# 390-394 BRUNSWICK ST

**Application No.:** PLN17/0941

Address of Property: 390-394 Brunswick Street, Fitzroy

**General description:** Part demolition and development of:

Left: Existing shopfront

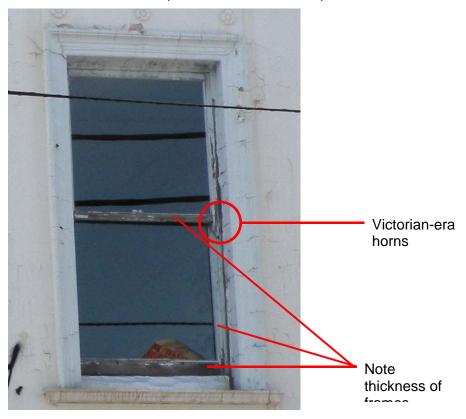
The existing shopfront does not appear to be original however its configuration (with fixed glazing, a stall and an angled ingo), timber frames and large panes of glass are typical of the Victorian style shopfronts. Removing this shopfront for the purposes of achieving DDA compliance is considered acceptable as no original fabric will be lost. The proposed replacement shopfront window should similarly be of Victorian configuration and constructed of timber.

Above: Sightline diagram showing extent of visibility of rooftop development from directly across Brunswick Street.

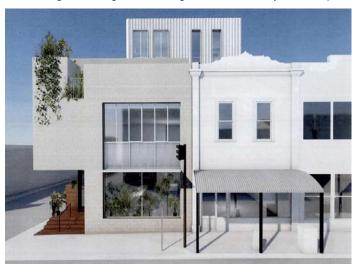
The submitted sightline drawing (shown below) indicates that only the topmost floor level (fourth floor) will be visible from the opposite side of the street. The visibility of just one floor level rising above the existing street front scale, is considered acceptable as will not dominate the streetscape.

Ground Floor Plan showing location of services

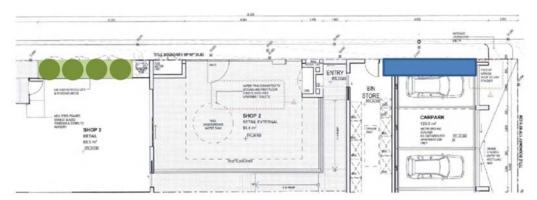
The location of services (water meter and hydrant booster) is not the best outcome for the corner as it does not contribute in providing interesting and positive public realm. It is highly recommended to explore moving the services towards the east outside the car parking area (as shown in blue below), hence the corner can be all landscaped. This will reflect the existing character and provides visual interest to the corner. It is acknowledged that this will

North Elevation shows that the doors for hydrant booster and water meter will be brick doors and it is unclear about practicality of this.

Existing location of services – recommend to be replaced with landscaping

Recommended location of services
